TO: Mercedes-Benz Dealer Principals, General Managers, Sales Managers, Service Managers, Parts Managers	FROM: Anthony Washington, Department Manager, Regulations and Certifications
<b>Re: Service Campaign Notification Model 907 (Sprinter) Model Year 2019-2020 Retrofit Propeller Shaft Holder Bracket</b>	DATE: June, 2022

Campaign No. 2022050016 June, 2022

SUBJECT: **Model 907 Model Year 2019-2020  
Retrofit Propeller Shaft Holder Bracket**

D41.10-A029-76

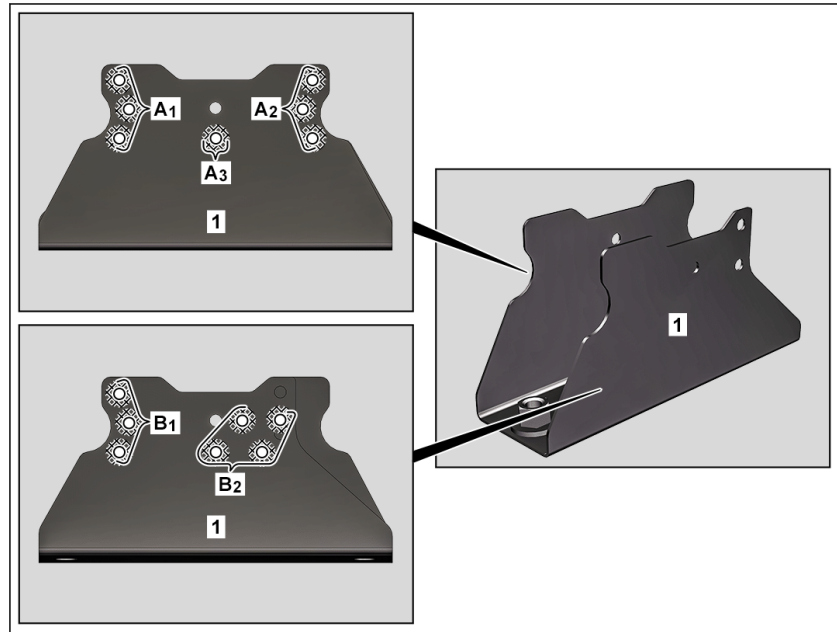
- 1 Make markings for holes (A<sub>1</sub>, A<sub>2</sub>, A<sub>3</sub>, B<sub>1</sub> and B<sub>2</sub>), as shown.

When doing so, maintain a distance of approx. 10 mm from edge of holder (1) for outer markings.

- 2 Drill holes (A<sub>1</sub>, A<sub>2</sub>, A<sub>3</sub>, B<sub>1</sub> and B<sub>2</sub>) into holder (1) with  $\varnothing$  7 mm.

- 3 Grind cross-hatched areas around holes (A<sub>1</sub>, A<sub>2</sub>, A<sub>3</sub>, B<sub>1</sub> and B<sub>2</sub>) down to bare metal.

D41.10-A030-78

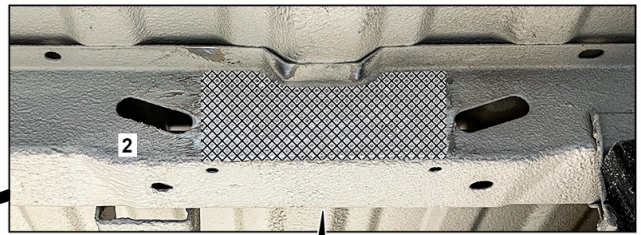
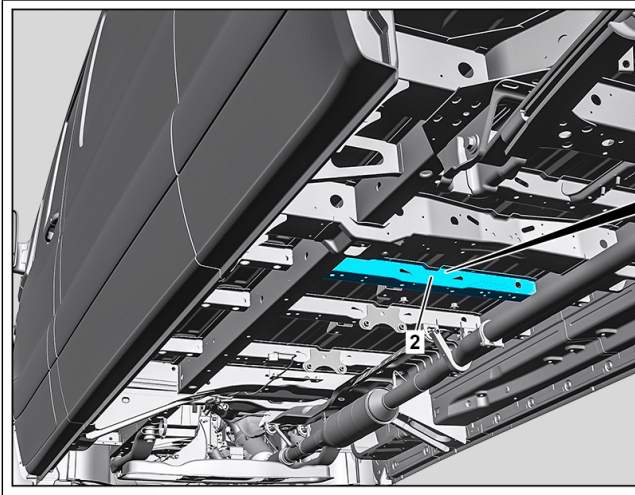
- 5 Remove underbody protection in cross-hatched areas from crossmember (2).

- 6 Grind cross-hatched areas down to bare metal on crossmember (2).

D41.10-A032-82

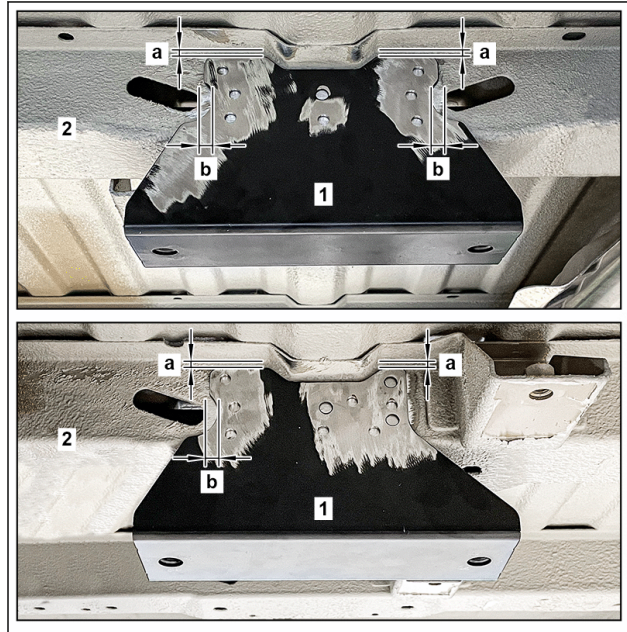
- 8 Attach holder (1) to crossmember (2), line up then fix in place.

Observe dimensions (A, B).

Dimension (a) is 5 mm.

Dimension (b) is 10 mm.

D41.10-A031-82

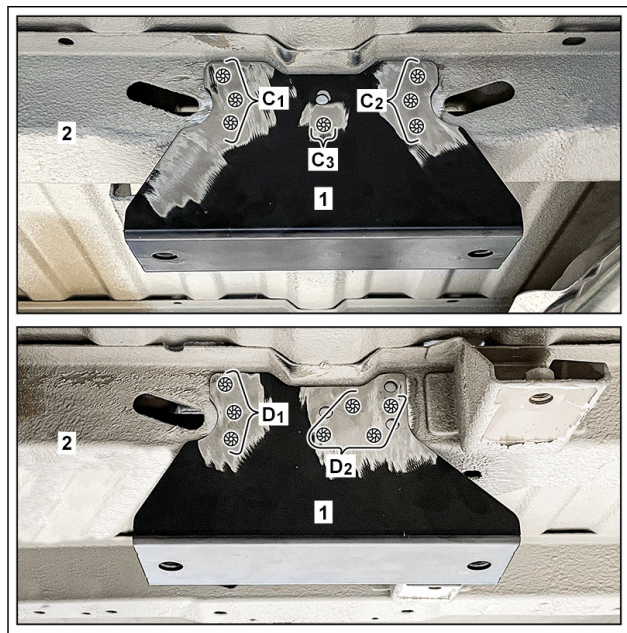
- 9 Holder (1)  $\text{sa}$  (areas C1, C2, C3, D1 and D2).

The holder (1) must lie flush on the crossmember (2) without any gap.

- 10 Clean weld joints and sheet metal flange.
